Replacemnt of T2293 with T1783

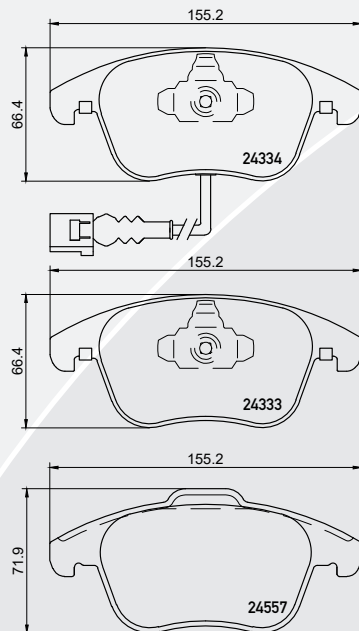
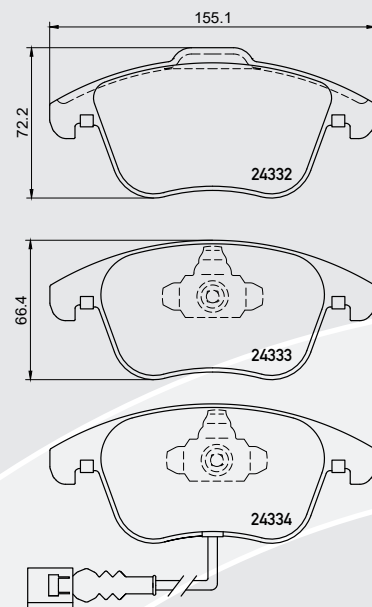
Pagid is now able to harmonize the references T2293 and T1783. It was proven that T1783 can also cover the applications of T2293. Therefore Pagid will replace T2293 with T1783.

The differences between T2293 and T1783 are the wrap around shim in the sliding areas of the pads. All other dimensions are equal or almost equal and have no effect on the function of the brake pads. Therefore there will be no difficulties during installation and operation.

As usual, existing stock of T2293 can be sold out without any problems.
